RE: File Nos.

- **Cambrian_37:** Annexation of two unincorporated parcels totaling 18.13 acres from the County of Santa Clara into the City of San Jose.
- **PDC17-040:** Planned Development Pre-zoning from unincorporated to CN(PD) Planned Development Zoning District to allow for a mixed-use project with up to 238 hotel rooms, up to 150,000 square feet of office, up to 115,000 square feet of commercial, up to 280 multifamily residential units, up to 70 townhouse residential units, up to 110,000 square feet of convalescent hospital, and 1.6 acres of public open space on a 18.13 gross acre site at the southeast corner of Union and Camden Avenues, commonly known as Cambrian Park Plaza Shopping Center.

Plan Set Comments on Planned Development Pre-Zoning (File No. PDC17-040)

Sheet 10.4: Conceptual Site Sections K-K at Public Park

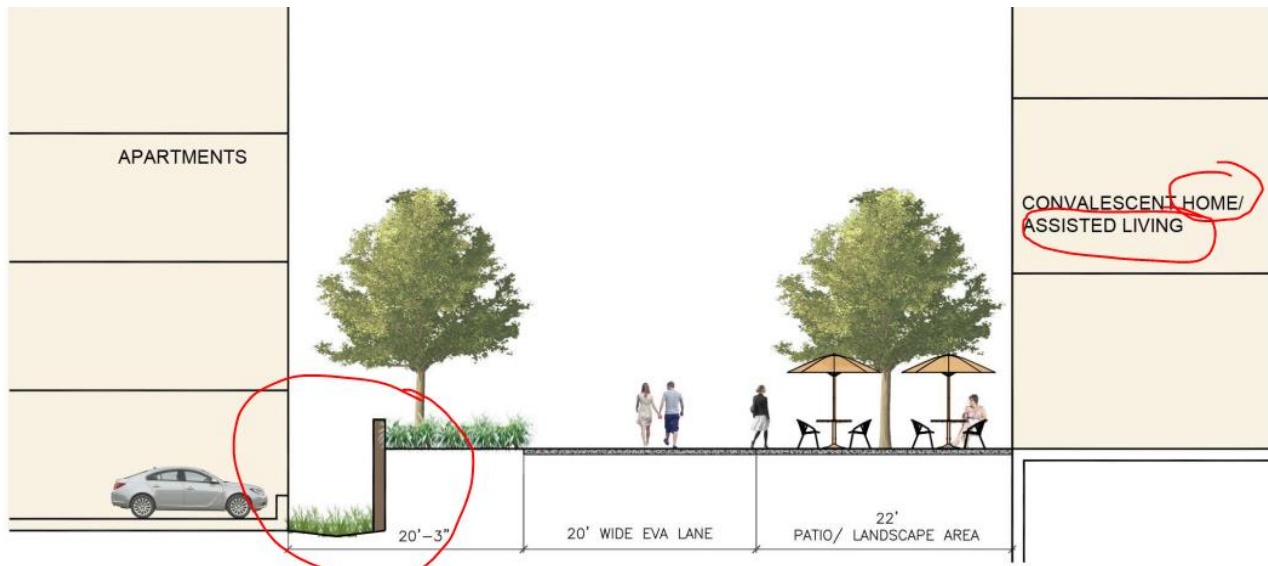
- Label the Convalescent Hospital correctly. This is not a residential use and must not use words to indicate otherwise.
- The stormwater pit is not acceptable. Remove this so the parking is completely below grade.
